Access Compliance Report

Public Rights-of-Way

(Curb Ramps)

Intersection ID: 27538	Main Street: ALTON_FARM_LN	Cross Street: CHARLOTTE_VIEW_DR	Location: SE
ADA ID: E845D4C6BF0A	Ramp Type: PerpDiag	Initial Pass/Fail: Fail	Overall Compliance: No
Severity Score: 25			
Codes/Mitigation Info/Possible Solution		Field Measurements/Component Compliance

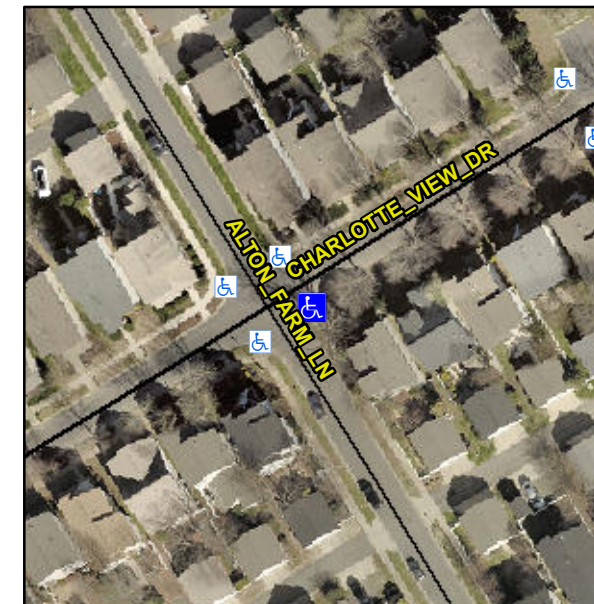
Not Found, R304.2.2

Compliance	Description	Data	Compliance	Description	Data
N/A	Ramp Length (in)	48.0	No	Ramp Slope (%)	19.3
Yes	Ramp Width (in)	48.0	Yes	Ramp XSlope (%)	1.0
N/A	Flare Type LT	N/A	N/A	Flare Type RT	N/A
N/A	Flare Slope LT (%)	N/A	N/A	Flare Slope RT (%)	N/A
N/A	Flare Traversable LT?	N/A	N/A	Flare Traversable RT?	N/A
N/A	Landing Length (in)	N/A	N/A	DWS Provided?	N/A
N/A	Landing Width (in)	N/A	N/A	DWS Contrast?	N/A
N/A	Landing Slope (%)	N/A	N/A	DWS Length (in)	N/A
N/A	Landing X Slope (%)	N/A	N/A	DWS Full Width?	N/A
N/A	Landing Curb? (Y/N)	N/A	N/A	DWS Offset (in)	N/A
N/A	Shared Landing?	N/A			
N/A	Gutter Ponding?	N/A	N/A	Gutter Slope (%)	N/A
N/A	Gutter Lip Ht (in)	N/A	N/A	Gutter X Slope (%)	N/A
N/A	Painted X Walk1?	No	N/A	Painted X Walk2?	No
	X Walk 1 Direction	To NW		X Walk 2 Direction	To SW
N/A	X Walk 1 Width (in)	N/A	N/A	X Walk 2 Width (in)	N/A
	X Walk 1 Slope (%)	0.1		X Walk 2 Slope (%)	0.2
	X Walk 1 X Slope (%)	1.6		X Walk 2 X Slope (%)	1.7

Remove & Replace Curb Ramp With Two New Directional Ramps or Equivalent.
